HISTORIC AND DESIGN REVIEW COMMISSION

August 1, 2018

HDRC CASE NO: 2018-328
ADDRESS: 230 ADAMS ST
LEGAL DESCRIPTION: NCB 943 BLK 1 LOT SW 100 FT OF 16
ZONING: RM-4 CD, H
CITY COUNCIL DIST.: 1
DISTRICT: King William Historic District
APPLICANT: Genevie Ramirez/Build Modern
OWNER: David Roberson/Build Modern
TYPE OF WORK: Exterior modifications, window replacement, porch modifications, construction of a rear addition and fencing
APPLICATION RECEIVED: June 29, 2018
60-DAY REVIEW: August 28, 2018
REQUEST:

Re: Adams Rehab – Project Narrative

WINDOW SCHEDULE PER STAFF'S SITE VISIT

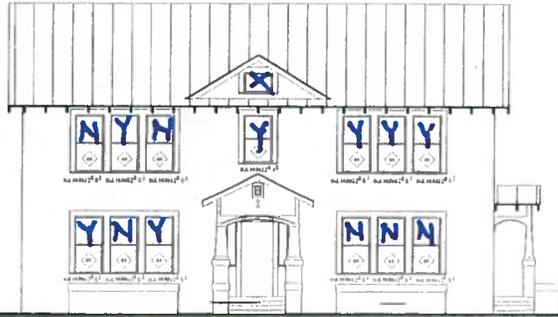
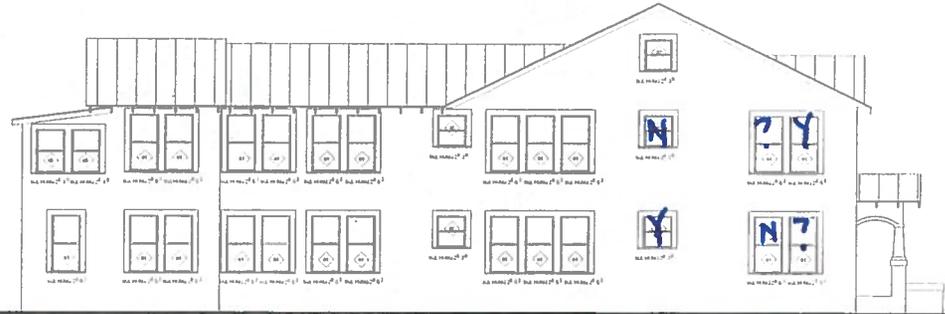
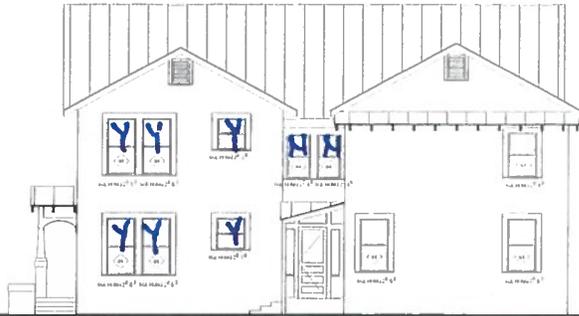
- f. **WINDOW REPLACEMENT** – The historic structure currently features historic, one over one wood windows. Many of the existing windows feature damage or are missing sashes. In some instances windows are completely missing. The Guidelines for Exterior Maintenance and Alterations 6.A.iii. notes that historic windows should be repaired. Staff performed a site visit on July 10, 2018, and found that many of the existing windows are in repairable condition. Staff has indicated these windows on elevation drawings located within the exhibits. Regarding window replacement, staff finds the proposed wood, one over one windows to be an appropriate replacement for windows that are deteriorated beyond repair.

- ii. That the proposed windows feature a depth that matches those found in the historic structure.
5. Staff recommends partial approval of item #5, window replacement, only where windows are non-repairable as noted by staff in the exhibits. Staff does not recommend approval of wholesale window replacement. The applicant may present additional information to staff regarding the replacement of windows that are deteriorated beyond repair that were not accessible to staff during the site visit.
